**SECTION 4.55(1A) MODIFICATION APPLICATION
Building R4A, One Sydney Harbour, Barangaroo South**

This modification application has been prepared by Ethos Urban on behalf of Lendlease (Millers Point) Pty Ltd, pursuant to section 4.55(1A) of the *Environmental Planning and Assessment Act 1979* (EP&A Act) to modify Development Consent SSD 6964 relating to Building R4A at Barangaroo South (the site). The proposed modifications relate to a reduction in the number of apartments, internal and external amendments, changes to finished floor levels and reallocation of car parking with the shared Stage 1B Basement.

Figure 1 Changes proposed to the sub-penthouse plan.

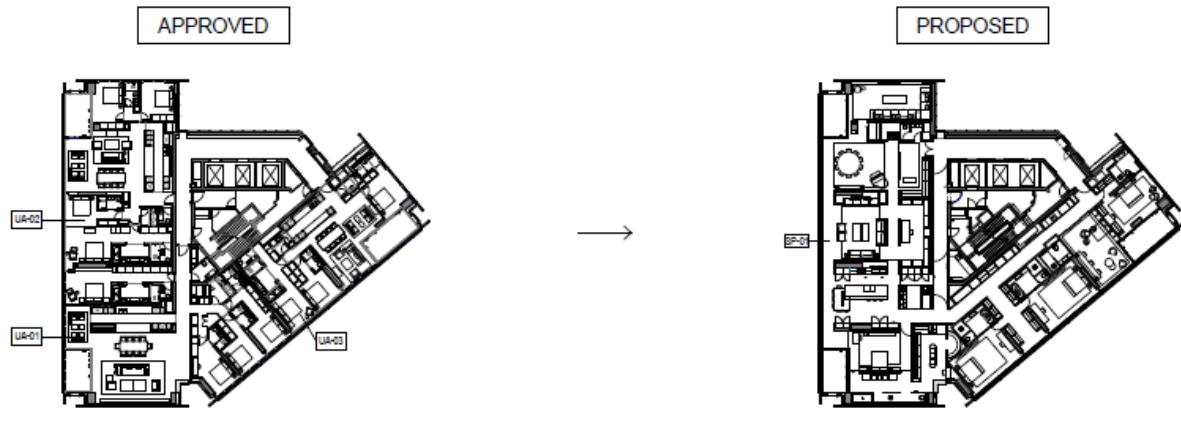
It is proposed that the uppermost floor plate of the R4A building (level 67), currently described as an 'upper plate' be changed to a new 'sub-penthouse plate'. At this level, the three separate apartments are proposed to be consolidated into a single apartment. The proposed new apartment on Level 67 is shown on the Architectural Plans at **Attachment A**, as well as **Figure 1**. The sub-penthouse plate will therefore be made up of one large apartment, reducing the overall number of apartments in Building R4A by two apartments. The adjusted dwelling mix in light of this change is outlined in **Table 1**.

Figure 2 Revised finished floor levels.

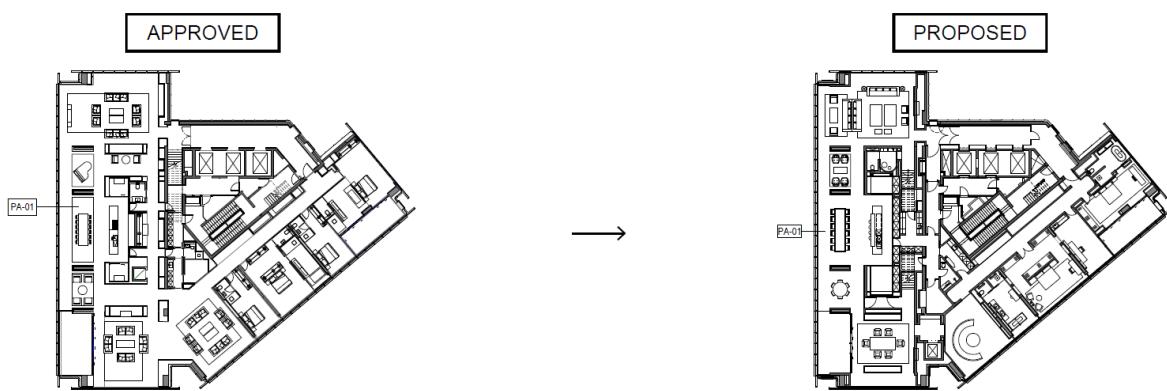
Through design development, the finished floor levels of the upper levels in the building have been revised to accommodate greater ceiling heights and achieve required ceiling services and floor finishes zones. This change will not result in any changes to the overall roof or parapet levels. The proposed changes only apply to Levels 67, 68 and 69, and are illustrated in **Figure 2**.

Figure 3 Changes to lower penthouse and upper penthouse levels.

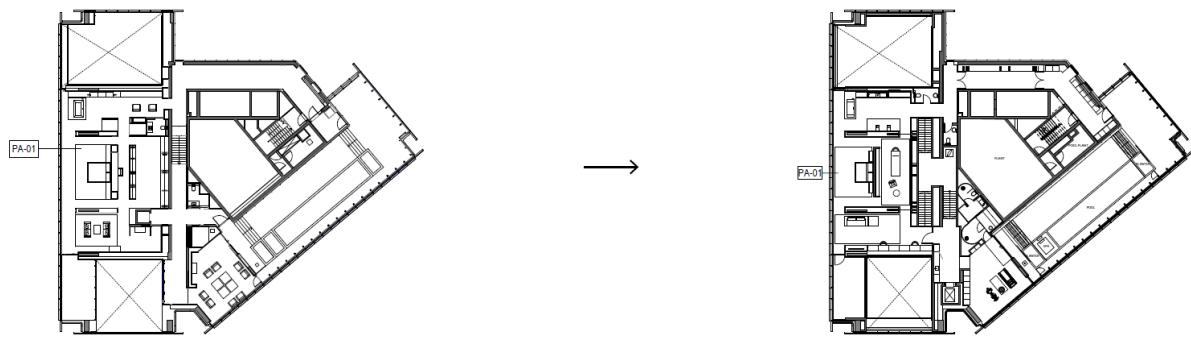
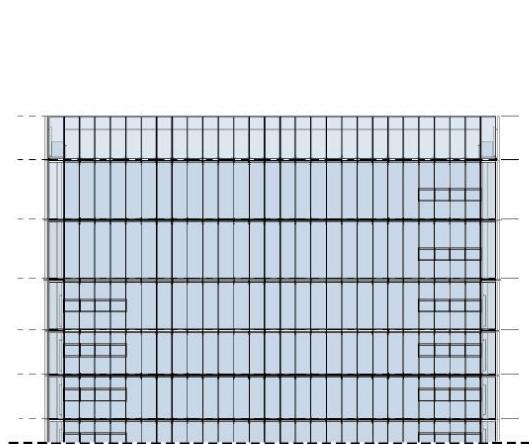
An internal reconfiguration and amendment of apartment layouts are also proposed to Levels 68 and 69. These changes are the result of further design review and an aim to provide high quality spaces within the apartments. The proposed amendments are illustrated in **Figure 3** and are also clouded on the Architectural Plans (refer to **Attachment A**).

Figure 4 Proposed façade amendments at levels 67-69

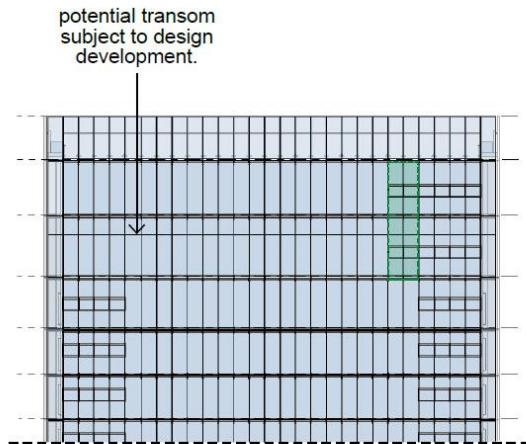
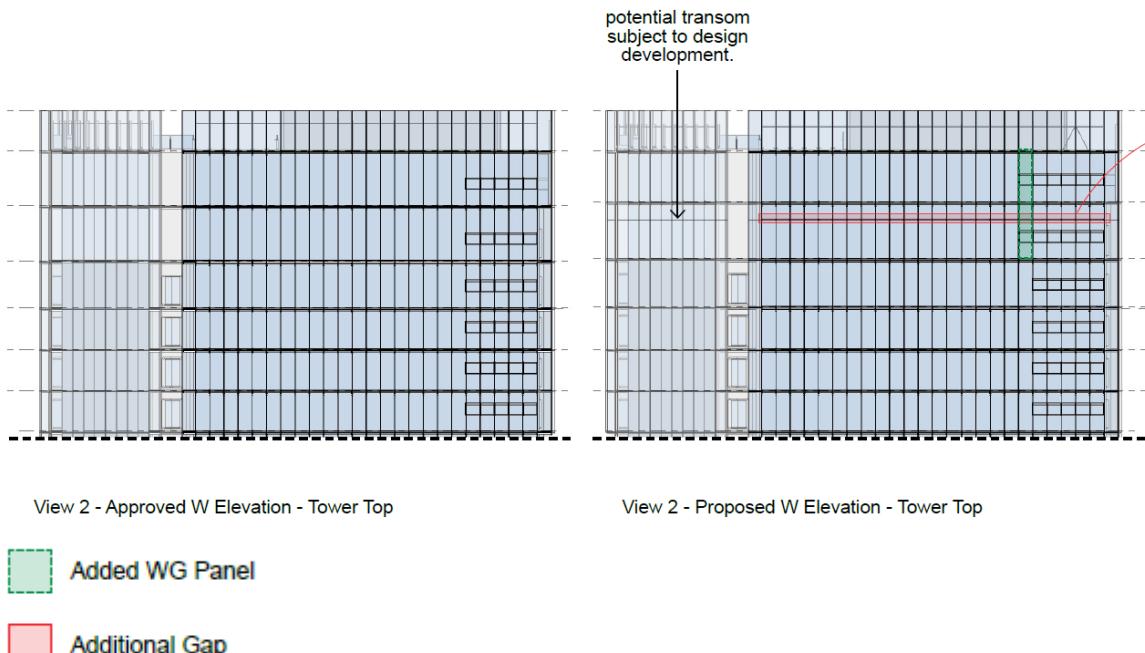
Due to the internal amendments proposed to Levels 67, 68 and 69 as outlined above, minor changes to the façade are proposed. The first of these changes is the introduction of two additional wintergarden façade bays on the northeast facade and one on the west facade at levels 68 and 69. This is proposed to align the façade elevations to the internal functions they serve.

Secondly, an additional gap is proposed in the façade of the western elevation, designed to conceal the pool structure within whilst allowing for operability of the open cavity façade on level 68 below. This detail sees an opaque panel introduced above the glazed operable façade system, creating a minimal gap in the façade to allow for ventilation.

In addition, provision for a transom is proposed on the north east elevation to provide for a glazing solution. It is noted that this is a provision only, with its requirement subject to detailed design development. These changes are illustrated at **Figure 4**.

Figure 5 The proposed location of the approved operable awning is shown in blue, and revised BMU configuration shown in green

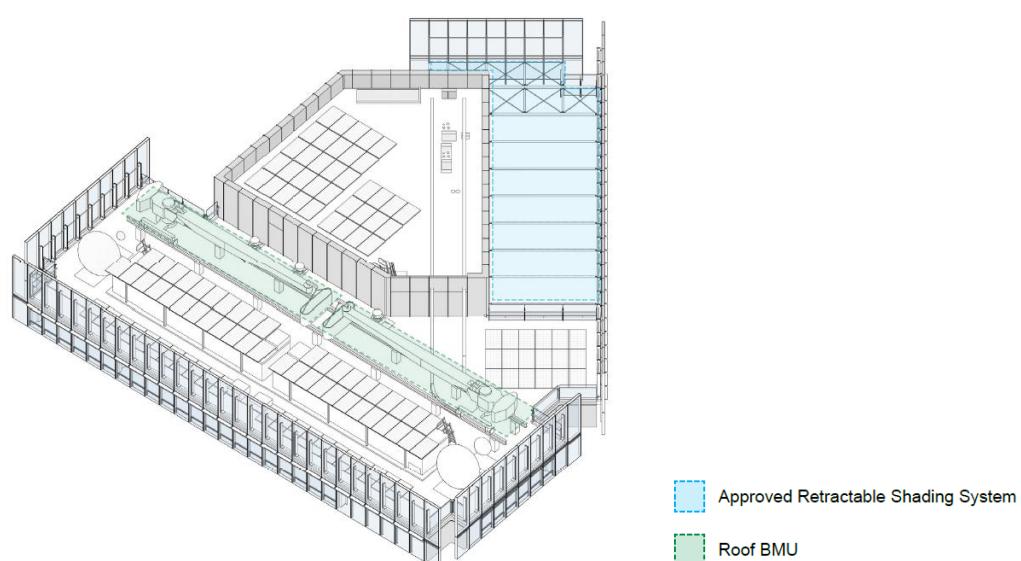
There are two amendments proposed to the roof of Building R4A. Firstly, the location of the approved retractable awning shading system for the outdoor rooftop area is clarified to be extendable over the whole outdoor space, as shown in blue in **Figure 5**. This was the approved with the original consent, however, to avoid doubt, the drawings have been updated to reflect this as it is currently unclear.

Secondly, the approved building maintenance unit (BMU) is proposed to be amended into two, smaller BMUs. The provision of two BMUs will not alter the overall height or general design of the roof, but will provide greater functionality to allow for faster cleaning cycles and maintenance downtime.

Figure 6 Signage zone comparisons

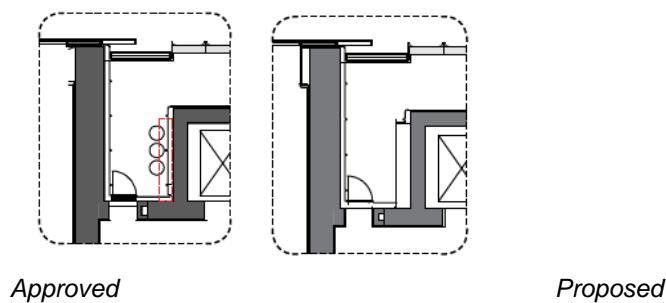
An additional building identification signage zone is proposed to be provided on the ground floor of Building R4A. This signage zone will sit vertically on a column to the left-hand side of the building entrance, in addition to the approved building identification signage zone above the entrance door. It is anticipated that the proposed signage will comprise individual lettering on the opaque surface adjoining the entrance, providing a solution which ties harmoniously into the architecture of the building. The revised signage configuration will enhance wayfinding and has been refined through design development. The proposed additional and approved signage zones are illustrated in **Figure 6**.
